AMERICAN POWER CONVERSION

DESCRIPTION: SB207 CIRCUIT BOARD SCHEMATIC — SHEET 2 OF 3

PRODUCT: MINI 250/400 BACK-UPS — APCC PART # 0S-207

DATE 3/18/91 — BY ESM — SCALE — DWG 640-0207D — REV 10

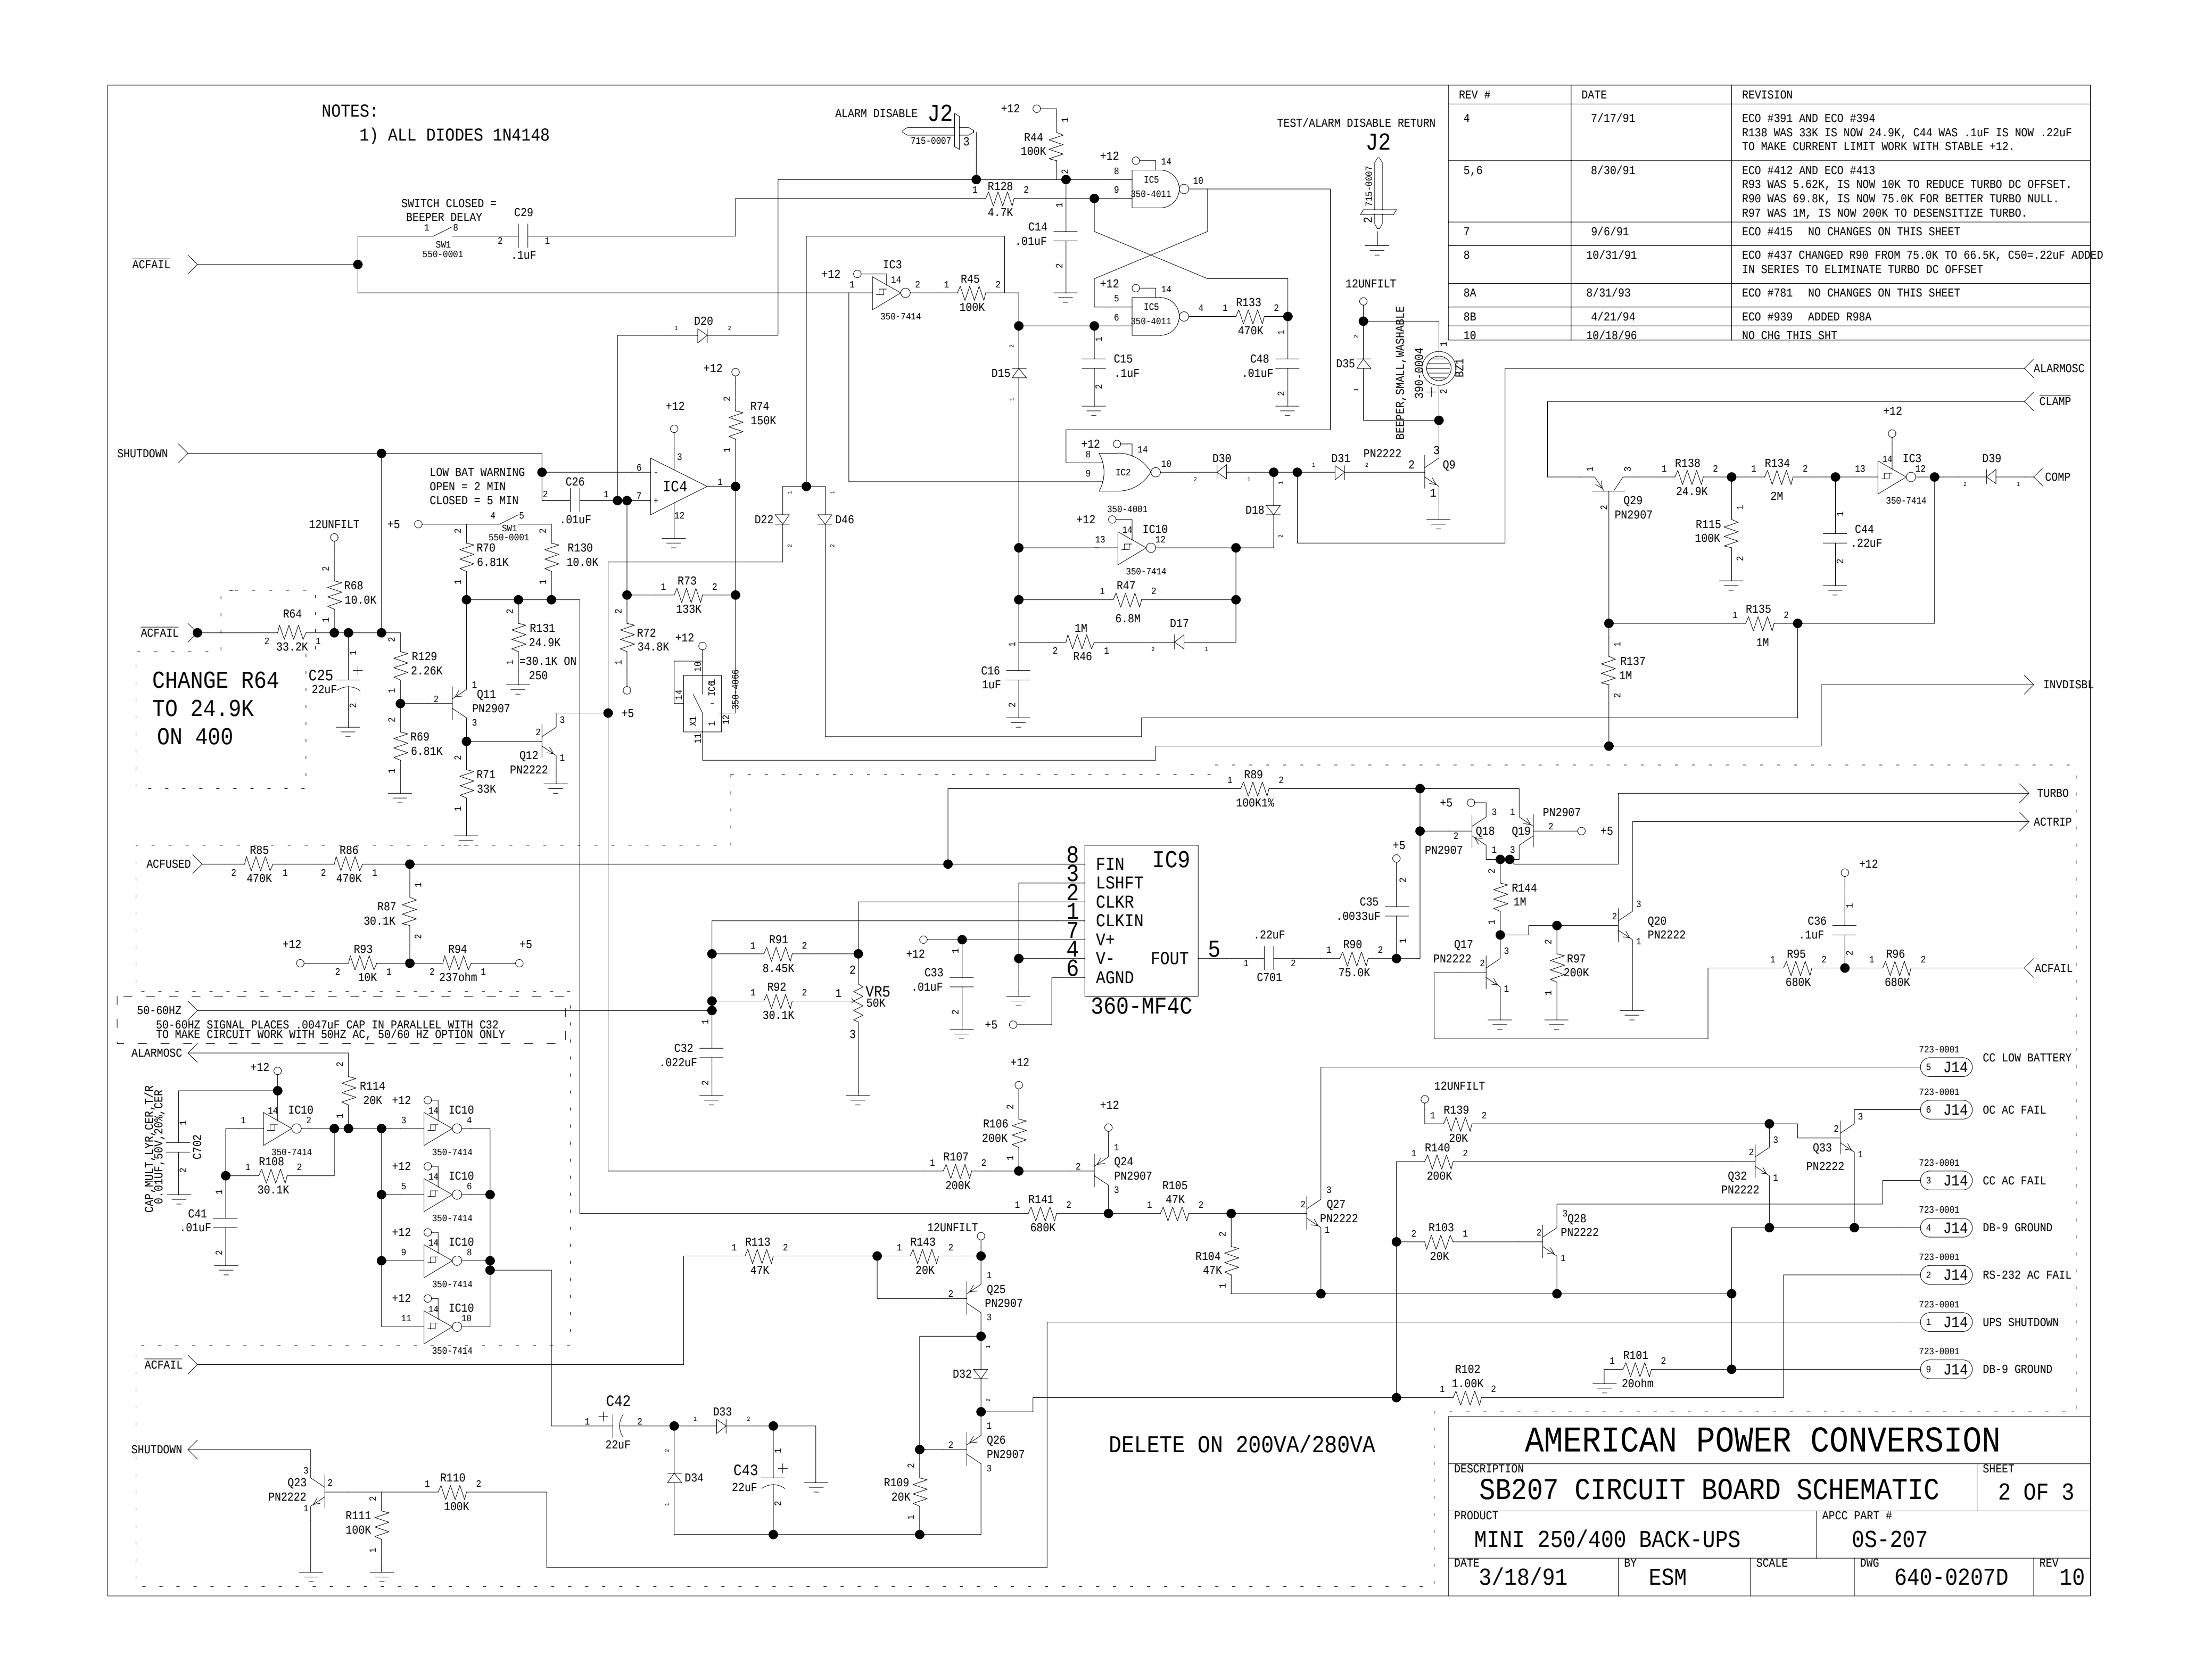
REV #	DATE	REVISION
4	7/17/91	ECO #391 AND ECO #394 R138 WAS 33K IS NOW 24.9K, C44 WAS .1uF IS NOW .22uF TO MAKE CURRENT LIMIT WORK WITH STABLE +12.
5,6	8/30/91	ECO #412 AND ECO #413 R93 WAS 5.62K, IS NOW 10K TO REDUCE TURBO DC OFFSET. R90 WAS 69.8K, IS NOW 75.0K FOR BETTER TURBO NULL. R97 WAS 1M, IS NOW 200K TO DESENSITIZE TURBO.
7	9/6/91	ECO #415 NO CHANGES ON THIS SHEET
8	10/31/91	ECO #437 CHANGED R90 FROM 75.0K TO 66.5K, C50=.22uF ADDED IN SERIES TO ELIMINATE TURBO DC OFFSET
8A	8/31/93	ECO #781 NO CHANGES ON THIS SHEET
8B	4/21/94	ECO #939 ADDED R98A
10	10/18/96	NO CHG THIS SHT
